UNITED STATES  
DEPARTMENT OF THE INTERIOR  
BUREAU OF LAND MANAGEMENTCarlsbad Field Office  
FORM APPROVED  
OMB NO. 1004-0137  
Expires: January 31, 2018SUNDRY NOTICES AND REPORTS ON WELLS  
Do not use this form for proposals to drill or to re-enter an  
abandoned well. Use form 3160-3 (APD) for such proposals.5. Lease Serial No.  
NMNM082

8. Well Name and No.  
BALLARD DE FED 49. API Well No.  
30-025-02467-00-S110. Field and Pool or Exploratory Area  
LYNCH11. County or Parish, State  
LEA COUNTY, NM

☒ Notice of Intent☐ Subsequent Report☐ Final Abandonment Notice☐ Acidize☐ Alter Casing☐ Casing Repair☐ Change Plans☐ Convert to Injection☐ Deepen☐ Hydraulic Fracturing☐ New Construction☒ Plug and Abandon☐ Plug Back☐ Production (Start/Resume)☐ Reclamation☐ Recomplete☐ Temporarily Abandon☐ Water Disposal☐ Water Shut-Off☐ Well Integrity☐ Other

\*\* BLM REVISED \*\* BLM REVISED \*\* BLM REVISED \*\* BLM REVISED \*\* BLM REVISED \*\*

WELL# BALLARD DE Fed 4

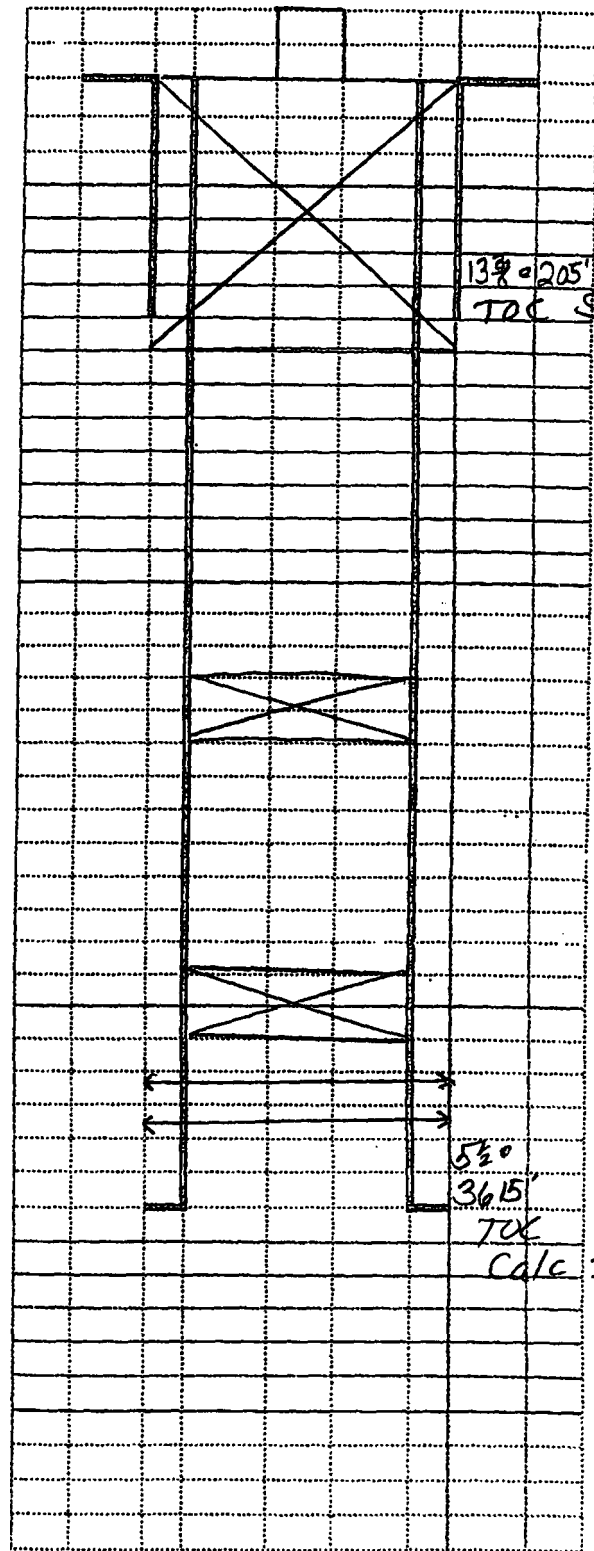
P+S  
255'  
Cement to  
Surf w/175'  
Verify

255X.  
2165'-2065'

5 1/2" CIBP  
3400'  
w/255X

1. Run a CBL. If CBL shows that there are only more than two casing string contact BLM. If there are only two strings continue with the procedure.
2. Set CIBP @ 3400 ft. Spot C Class C from 3400 to 3130ft. WOC and TAG.
3. Perf at 3130 ft. Squeeze from 3130ft to 2630ft. WOC and TAG.
4. Perf at 2630ft. Squeeze from 2630ft to 2065ft. WOC and TAG.
5. Perf at 255 ft. Squeeze from 255ft to surface.
